Identifying the A907 Z-Motor Bundle

What is the A907?

Old Head Termination Board (left); New Head Termination Board (right)

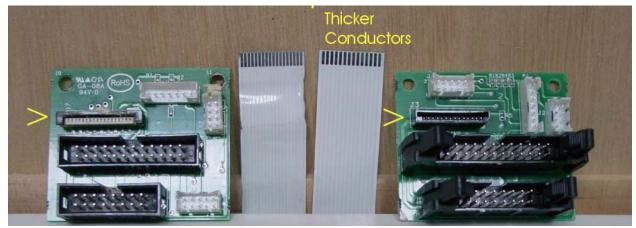
The A907 Z-Motor Bundle consists of a new layout of the Z-motor electronics board, 14 pin FFC cable and Head Termination Board. It is a modification that was made to the hardware during early manufacturing of the "A" model machines near the beginning of 2007. Later "A" models were manufactured, sold & shipped with the A907 already installed. If your machine is a "B" or "C" series machine, it was manufactured with the A907 design and you do not need the upgrade.

For the remaining "A" series machines, identification is best made by looking at your Head Termination Board, located on the back of the horizontal Y railing and compare it to the board versions seen in the picture below. The old 18-pin FFC cable (indicated with >) is not available and LHR only sells the 14 pin FFC cable. The new board also has "locks" (spring clip connectors) on the two larger ribbon cable connectors. The old board does not have these "locks".

There are still machines running just fine that have not had the A907 upgrade, just as there are Beta machines still in operation. However, should you ever need to replace the Head Termination Board, Z-motor, FFC cable, or if you want to be able to use a Scanning Probe in a new Z-truck, or upgrade to the CarveTight Spindle, you will need the A907 upgrade.

WARNING: PLUGGING A 14-PIN FFC CABLE INTO AN 18-PIN CONNECTOR MAY CAUSE DAMAGE TO SOME OF YOUR MACHINE ELECTRONICS
